UNITED STATES PATENT AND TRADEMARK OFFICE

10/542,067

Office Action Summary	Application No. 10/542,067	Applicant(s) KUBOTA, KATSUHIRO	
	Examiner ANATOLY VORTMAN	Art Unit 2835

DETAILED ACTION

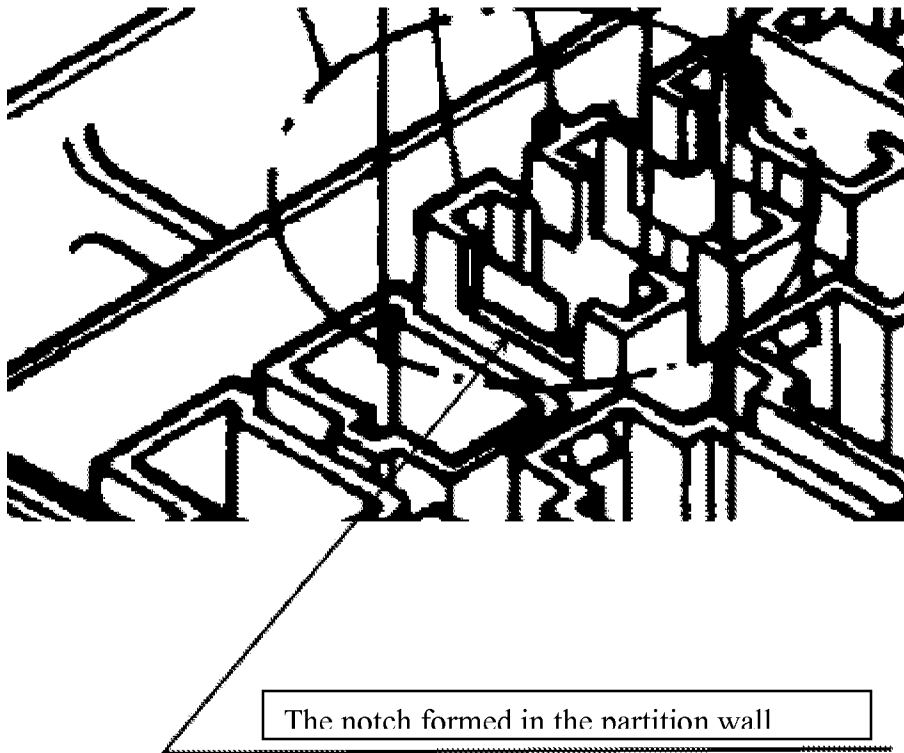
8. Claims 13 and 14, as best understood, are rejected under 35 U.S.C. 102(e) as being anticipated by US/6,585,541 to Higashida et al (Higashida) (of record).

Regarding claims 13 and 14, Higashida disclosed (Fig. 1) an electric connection box (1) comprising a fuse cavity structure (A), the fuse cavity structure including: a housing provided with a plurality of fuse attachment portions divided by partition walls, a large-sized fuse (10) and a small-sized fuse (8) shorter than the large-sized fuse being attachable to the fuse attachment portions, wherein the fuse attachment portions are adapted to accommodate the whole small-sized fuse (8), and wherein a part of the partition wall which is opposed to a part of the small-sized fuse accommodated in the fuse attachment portion is cut to form a notch (not numbered) to communicate with adjacent fuse accommodating portions (see Fig. 3, which clearly shows a notch formed in the partition wall, see also annotated fragment of Fig. 1 below).
